MARC Rail Communities Sector Plan – Worksession One

Planning Staff presented the Working Draft MARC Rail Communities Sector Plan on December 21, 2017. The Public Hearing for the was held at the BlackRock Center for the Arts on February 1, 2018. The Montgomery County Council has determined that it cannot complete review of the Sector Plan before November’s election. Council review of the Plan and the subsequent Sectional Map Amendment will occur during 2019.

This is the first worksession for the MARC Rail Communities Sector Plan. It will to provide the planning context that is the basis for the MARC Rail Communities Sector Plan. Future worksessions will review each plan recommendation section.

Figure 61
Staff Concept for Germantown Zoning

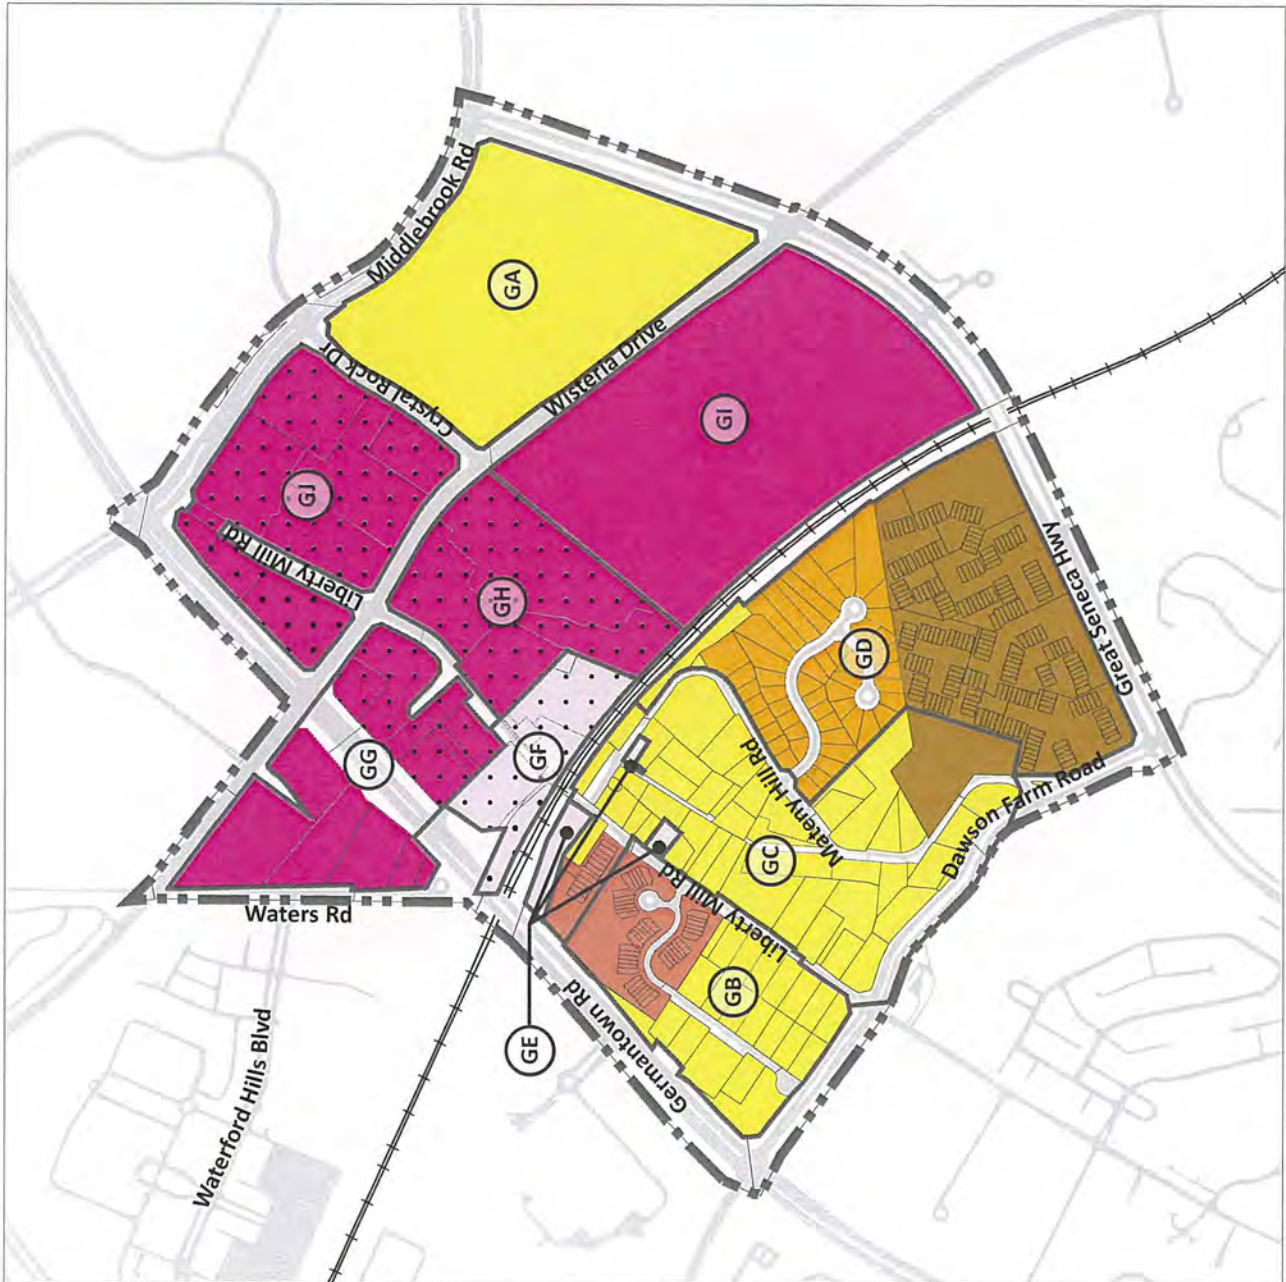
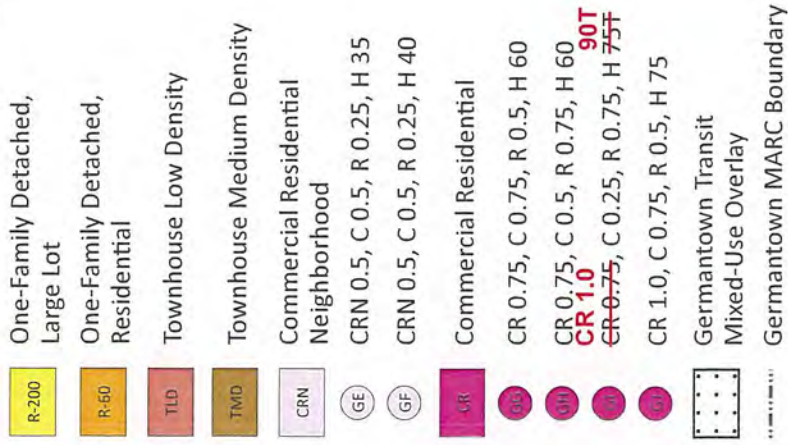
In the Working Draft, Staff recommends downzoning the Property from CRT-1.5, C-0.5, R-1.0, H-90T to CR 0.75, C-0.25, R-0.75, H-75T (*i.e.* reducing maximum permitted FAR by .75, commercial and residential FAR by .25, and building height by 25'). We understand that the intent of the Working Draft is not to downzone the Property but rather, reflect the height and density recommendations of the 2009 Sector Plan. To achieve this goal, **we are requesting that the Property be rezoned CR-1.0, C-0.25, R-0.75, H-90T.**

- **Page 93:**
 - Zone the Property Commercial Residential **CR-1.0 0.75, C-0.25, R-0.75, H-90T 75T** (see **Exhibit "A"**); and
 - Add note to clarify that it is Staff's intention to remove the 25 dwelling unit/acre cap recommended in the 2009 Sector Plan (see **Exhibit "A"**).
- **Page 97:** **CR-1.0 0.75, C-0.25, R-0.75, H-90T 75T** (see **Exhibit "B"**);
- **Page 81:** To reflect current zoning and recommendations in the 2009 Sector Plan, remove reference to site GI (see **Exhibit "C"**).
- **Page 86:** Delete references to specific height restrictions for step-down (see **Exhibit "D"**).

- Commercial Residential Neighborhood (CRN 0.5, C 0.5, R0.25, H 35) zone.
- Replace the Commercial Residential zone (CR 2.0, C 1.5, R 1.5, H40T) with the Commercial Residential Neighborhood zone (CRN 0.5, C 0.5, R 0.25, H 40) to reflect the confirmation of the land uses, heights and densities in this plan.
- Replace the Commercial Residential Town (CRT 1.5, R 0.5, R 1.0, H90T) with the Commercial Residential (CR ~~0.75~~, C 0.25, R 0.75, ~~H75T~~ **H90T**) ^{1.0}

Figure 56 - Staff Concept for Germantown Heights

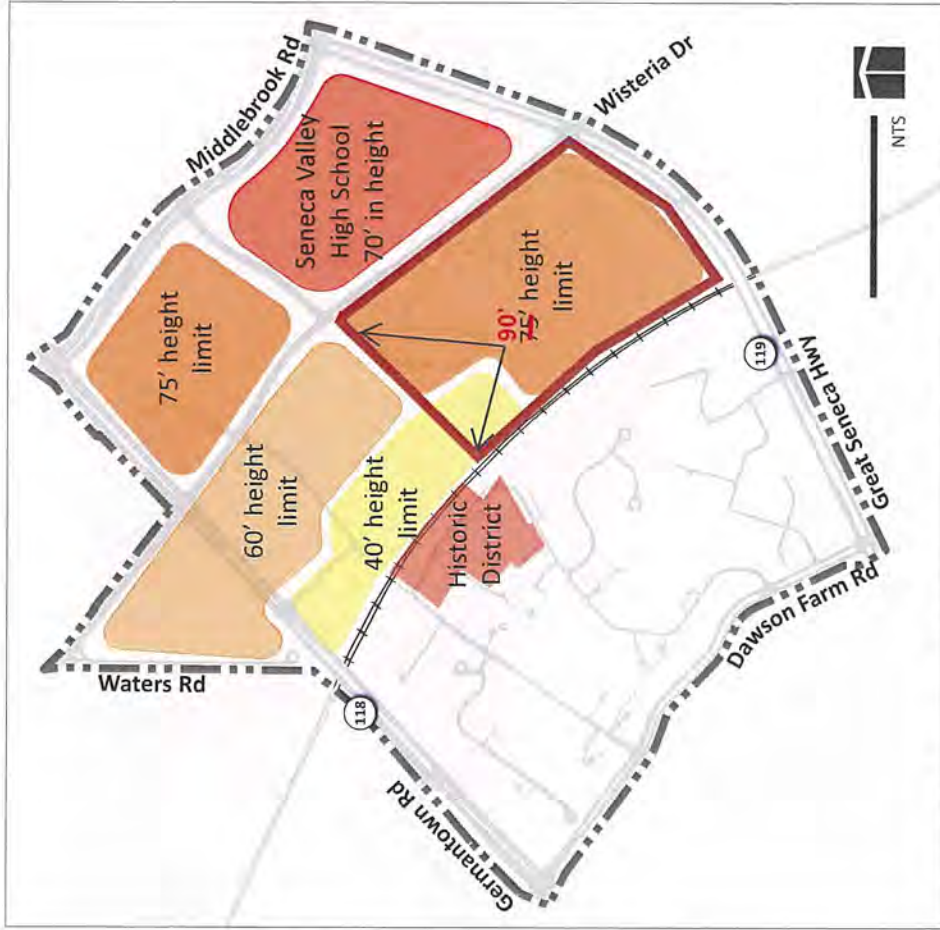
Similarly, the 2009 Sector Plan recommended that the Property be zoned at 90 feet, with additional language to ensure compatibility. This height recommendation should stand. There have been no changes since the 2009 Sector Plan to warrant a different recommendation. As such, we are requesting that the building height remain at 90T, to reflect the heights recommended in the 2009 Sector Plan. The 2009 Sector Plan provided an in-depth look at compatibility issues and determined that a maximum building height of 90 feet was appropriate on the Property to achieve compatibility. The 2009 Sector Plan included a discussion regarding concentrating tallest building heights toward the center of the Property and stepping down to lower building heights at the perimeter, where the edge of the Property faces the historic district. The County Council recommended no specific height limits for these "step-downs", but rather put in place parameters, as is appropriate and consistent with other master plans. As the Planning Board has done with recent plans, we are requesting that enough flexibility is provided to determine compatibility issues in connection with future development plans, when the design can be reviewed comprehensively. As such, we are requesting that reference to site GI be deleted from page 81, as a recommendation for lower heights on the entire Property is inconsistent with the current zoning and 2009 Sector Plan. Additionally, page 86 should be revised to allow for a maximum overall height of 90' on the property, and that specific height limits for the "step-down" should be removed.

- Allow building heights to step up to 75 feet on Germantown Road, Middlebrook Road and Great Seneca Highway (Sites GA and GJ).
 - ~~[Limit building heights to 60 feet along Walter Johnson Road, Wisteria Drive and Crystal Rock Drive, to relate to the narrower rights-of-ways (Sites GG, GH and GJ).]~~

Figure 2
 Boyds and Germantown MARC Station areas with walk radii

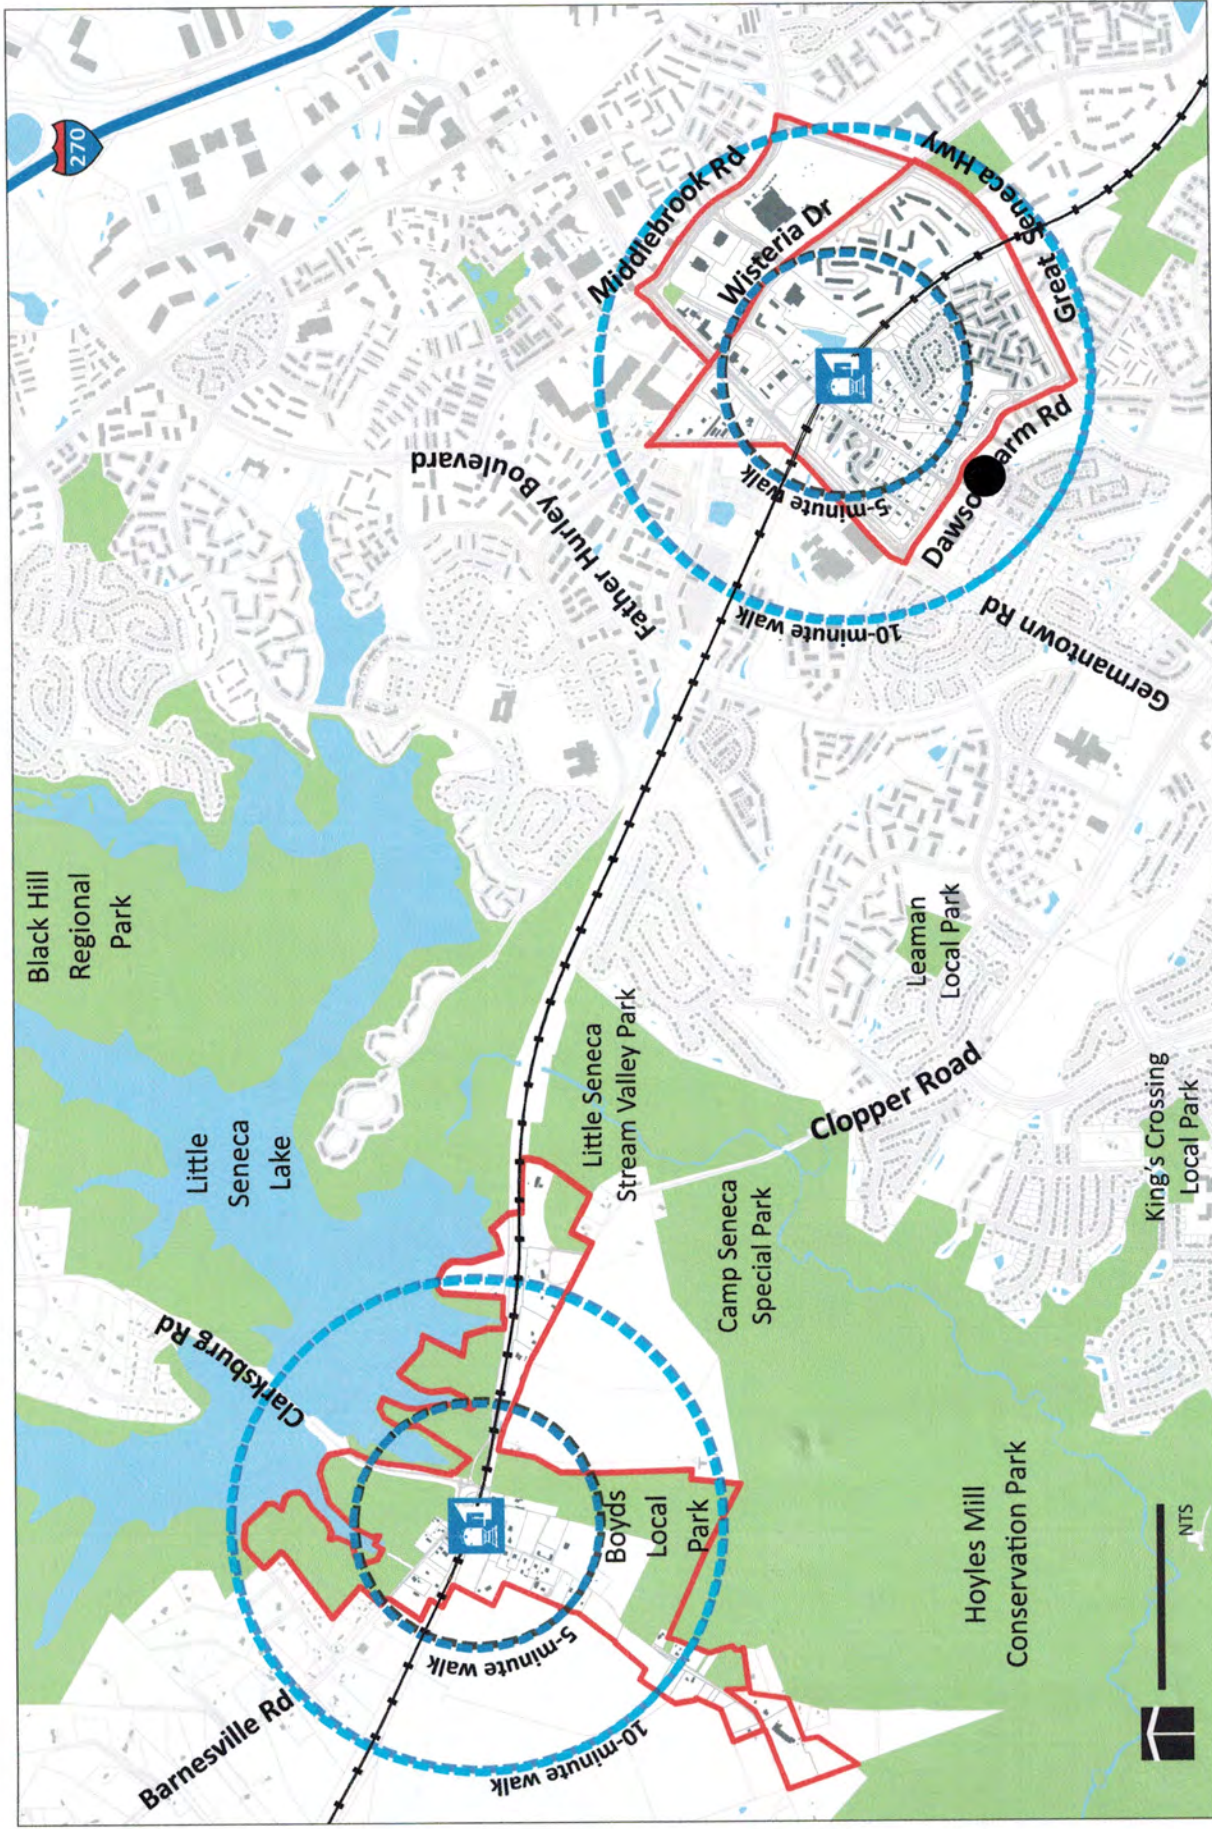
This property is just outside the boundary of the MARC Rail Communities Plan but is well within the 10-minute walk ring shown on Figure 2 and in fact is located closer to the MARC station than many properties currently included within the Plan's boundaries and is along Liberty Mill Road that is shown as a neighborhood main street on Figure 8. I have attached several exhibits from the plan indicating the location of this property with a black dot.

We are therefore requesting that the boundaries of the MARC Rail Communities Plan be minimally extended to include this property and that consideration be given to rezone this property from R-200 to RT-12.5. This new zoning classification would be compatible with the development in the area directly east of the property (townhouses) as well as with the institutional uses directly west and south of the property.
